Access Compliance Report

Public Rights-of-Way

(Curb Ramps)

Intersection ID: 42362	Main Street: OSPREY_KNOLL_DR	Cross Street: HERON_GLEN_DR	Location:	N
ADA ID: 945111BDC94D	Ramp Type: BlendTrans1	Initial Pass/Fail: Fail	Overall Compliance: No	Severity Score: 8.75

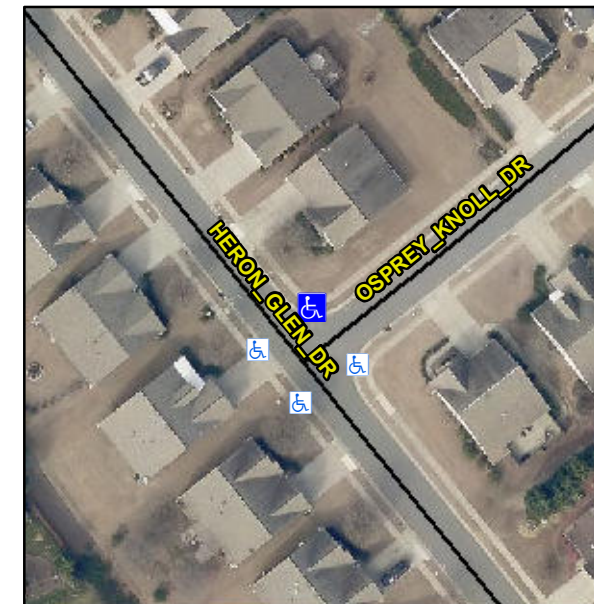
Compliance	Description	Data	Compliance	Description	Data
N/A	Ramp Length (in)	60.0	Yes	BlendTrans Slope (%)	2.4
No	Ramp Width (in)	39.0	Yes	BlendTrans XSlope (%)	1.1
N/A	Flare Type LT	N/A	N/A	Flare Type RT	N/A
N/A	Flare Slope LT (%)	N/A	N/A	Flare Slope RT (%)	N/A
N/A	Flare Traversable LT?	N/A	N/A	Flare Traversable RT?	N/A
N/A	Landing Length (in)	N/A	N/A	DWS Provided?	N/A
N/A	Landing Width (in)	N/A	N/A	DWS Contrast?	N/A
N/A	Landing Slope (%)	N/A	N/A	DWS Length (in)	N/A
N/A	Landing X Slope (%)	N/A	N/A	DWS Full Width?	N/A
N/A	Landing Curb? (Y/N)	N/A	N/A	DWS Offset (in)	N/A
N/A	Shared Landing?	N/A			
N/A	Gutter Ponding?	Yes	N/A	Gutter Slope (%)	N/A
N/A	Gutter Lip Ht (in)	N/A	N/A	Gutter X Slope (%)	N/A
N/A	Painted X Walk1?	No	N/A	Painted X Walk2?	No
	X Walk 1 Direction	To SW		X Walk 2 Direction	To SE
	X Walk 1 Width (in)	N/A		X Walk 2 Width (in)	N/A
	X Walk 1 Slope (%)	1.3		X Walk 2 Slope (%)	1.0
	X Walk 1 X Slope (%)	1.1		X Walk 2 X Slope (%)	3.7

N/A	Ramp inside XWalk1?	N/A	N/A	Ramp inside XWalk2?	N/A
	Road Slope (%)	1.7		Clear Space?	N/A
	Road X Slope (%)	1.3	N/A	Clear Space to XWalk (in)	N/A
N/A	Any Obstructions?	N/A	N/A	Storm Grate/Utility Hazard?	N/A
	Obstruction Type			Storm Grate/Utility Type	
		N/A			N/A
			Yes	Surface Condition? (G/P)	Good
			N/A	Curb Slope (%)	4.4

Remove & Replace Curb Ramp With Two New Directional Ramps or Equivalent.
